ARCHITECT'S ADDENDUM

Addendum Number: 008

RE: KANE COUNTY - Multi-Use facility

Subject: Addendum No. 008 to the Construction Documents for the Kane County Multi-Use Facility.

LOCATION MAP

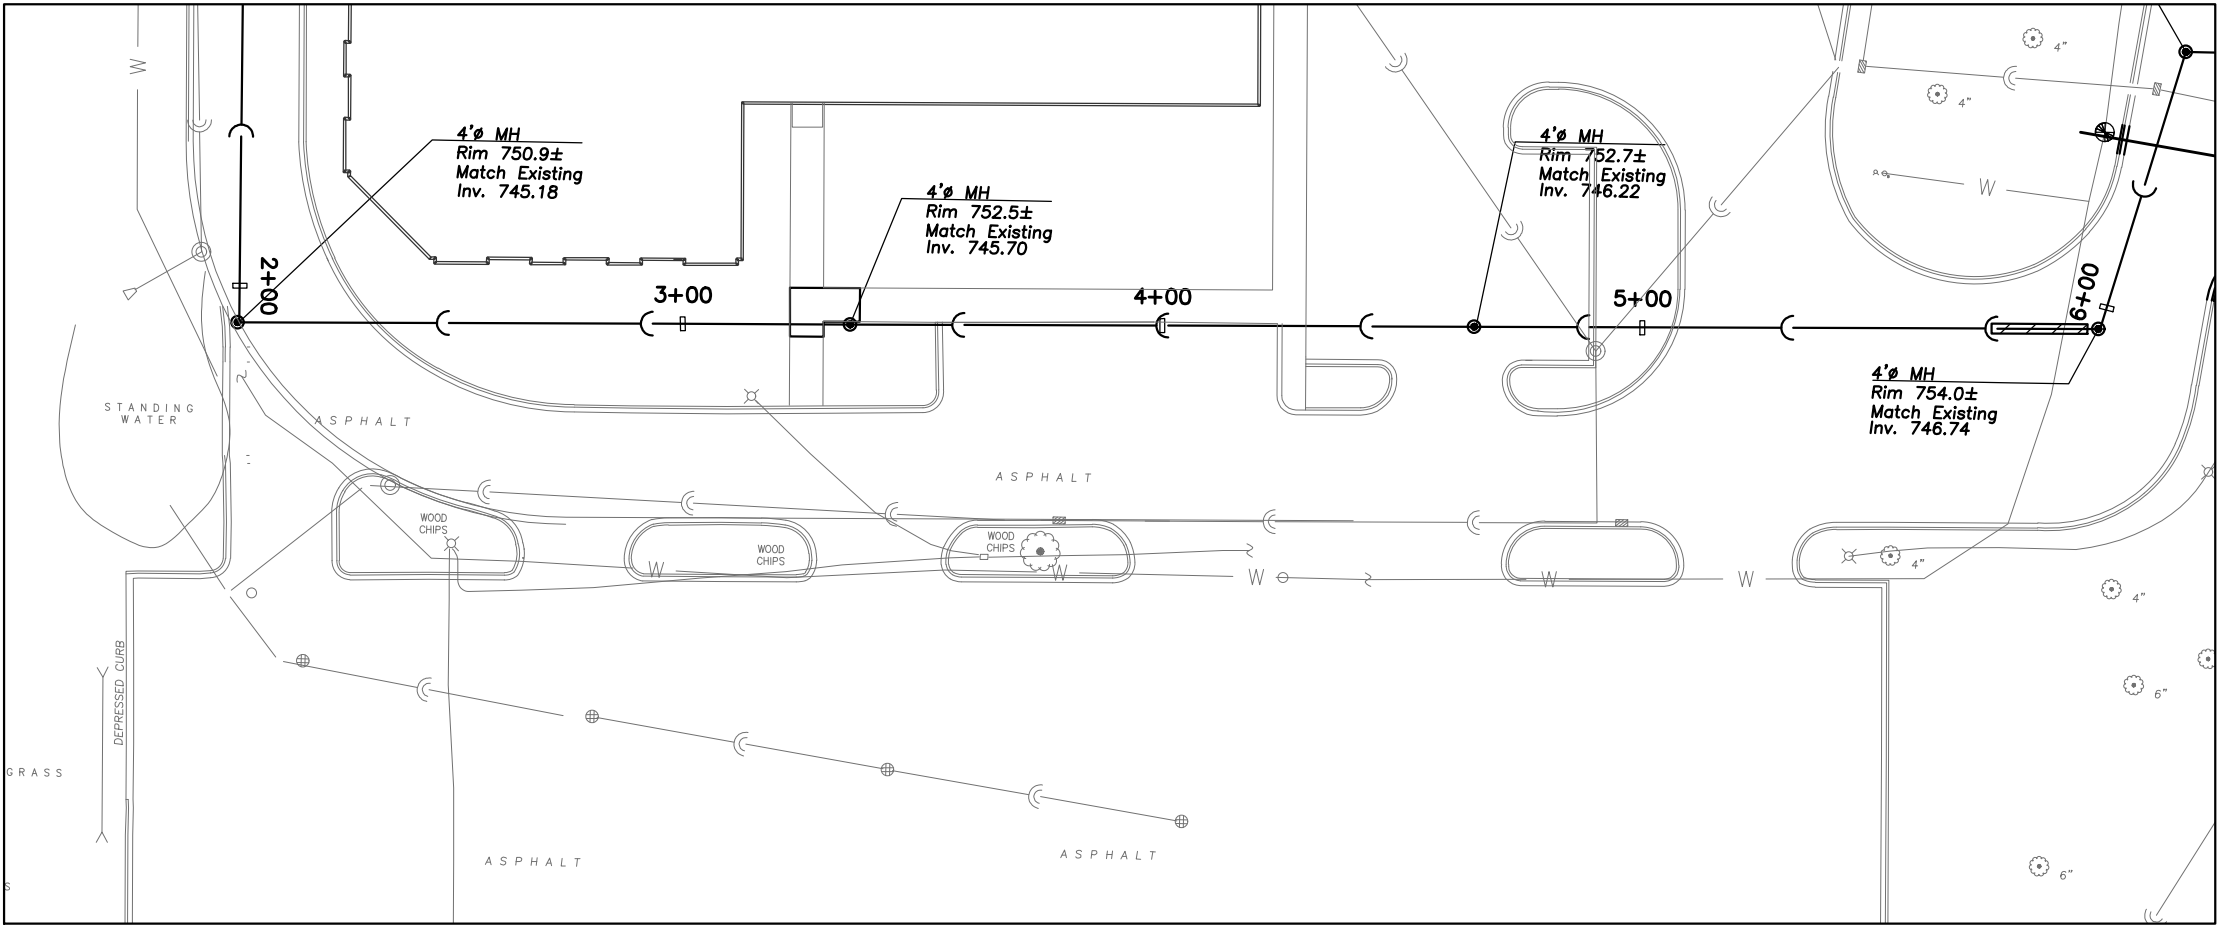
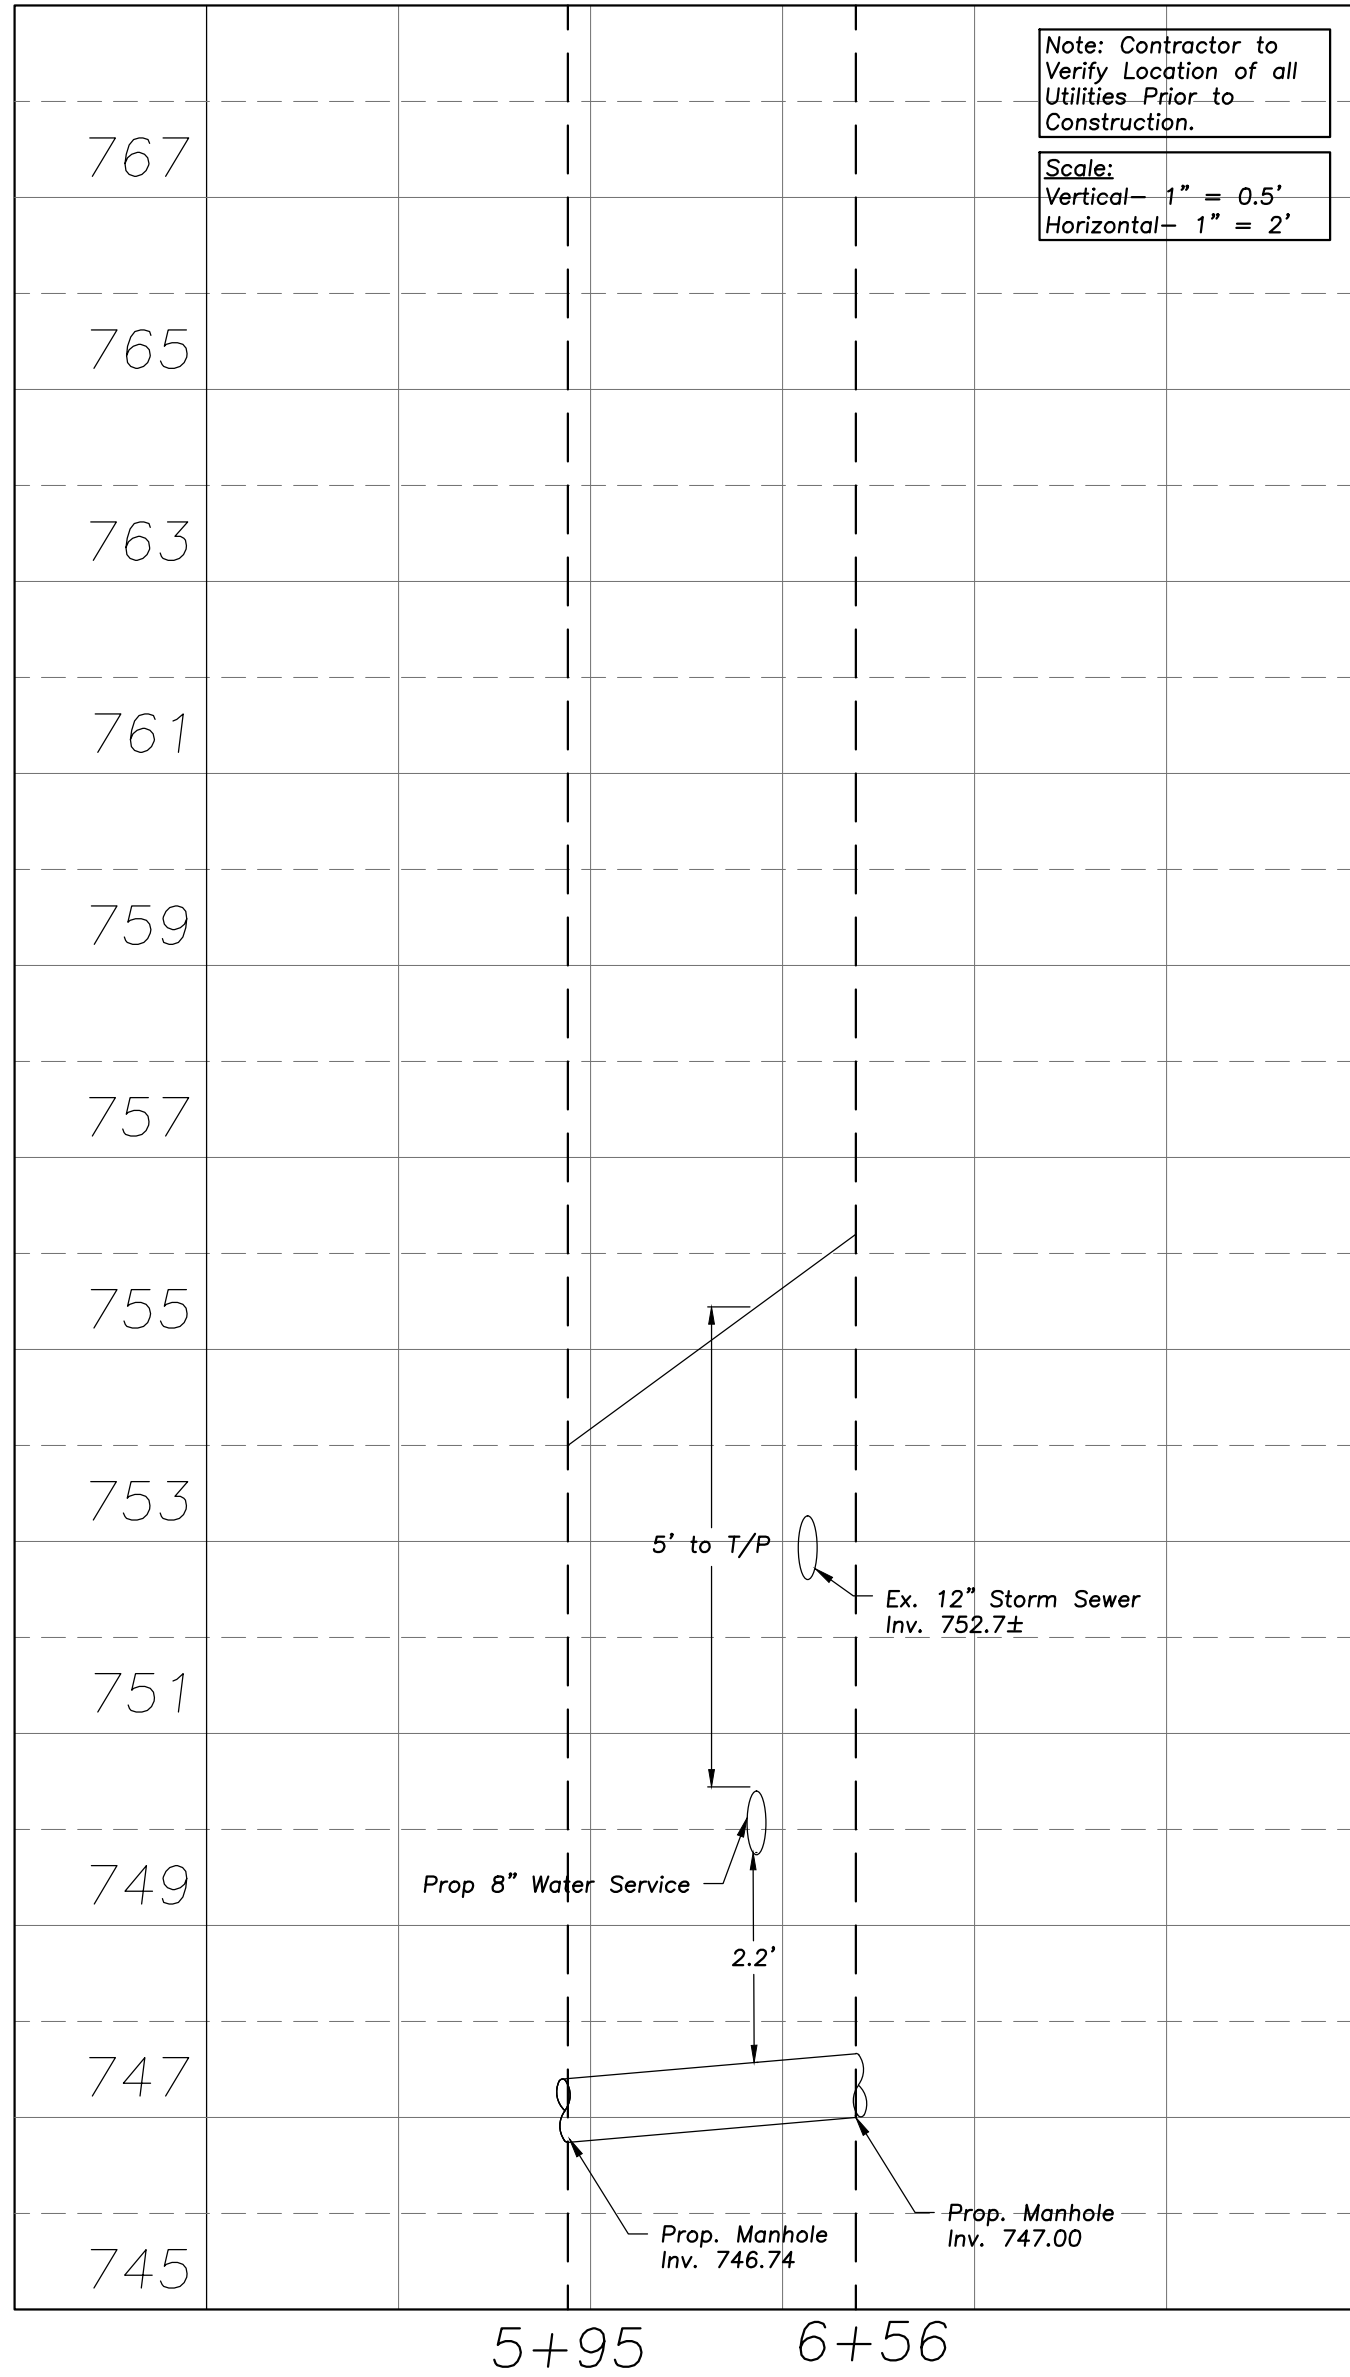
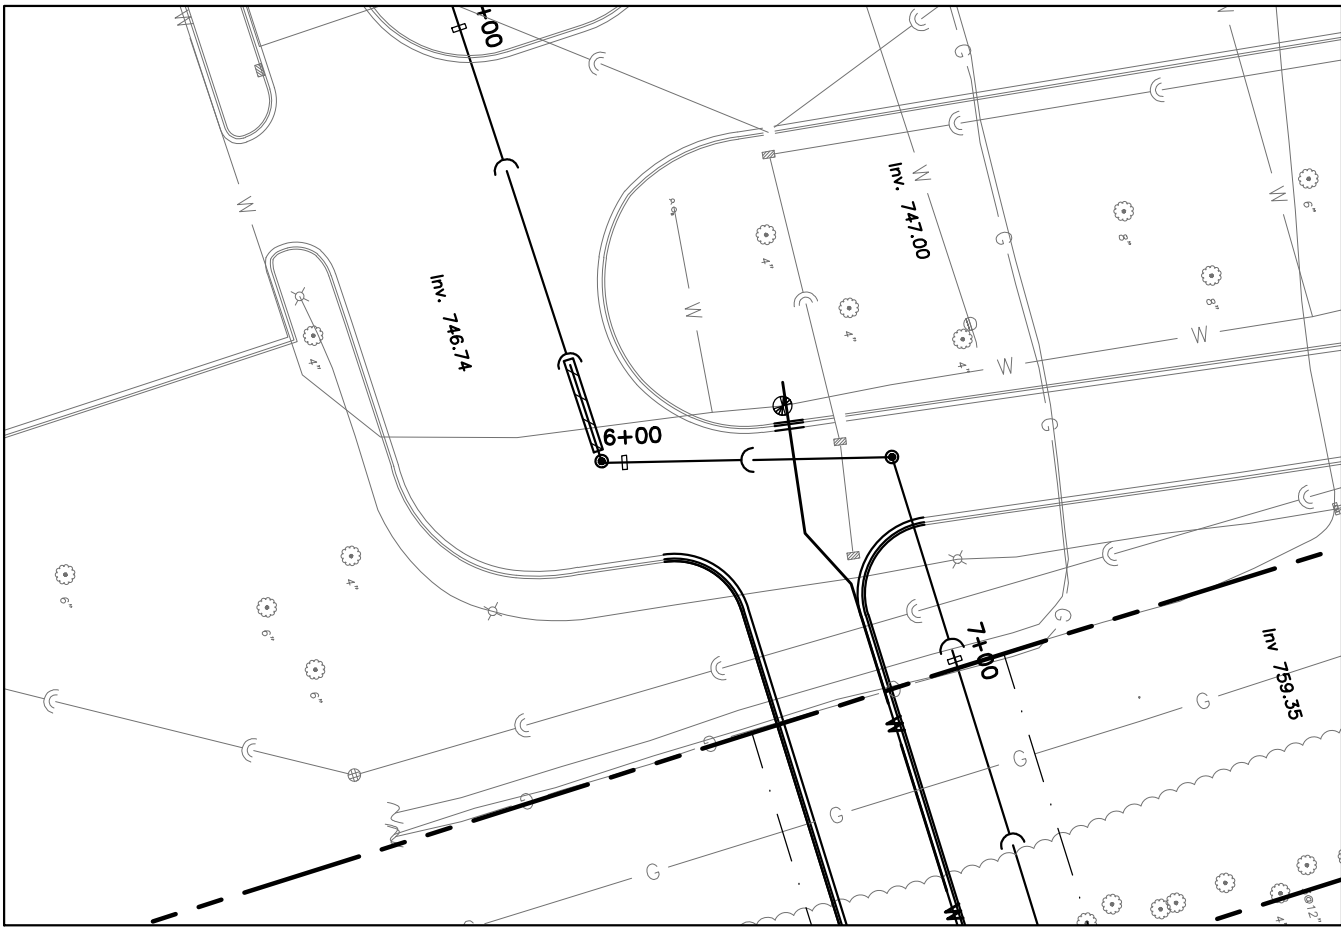
- C3.1 Site Utility Plan
- C6.0 Sanitary Sewer Plan and Profile
- C6.1 Sanitary Sewer Plan and Profile
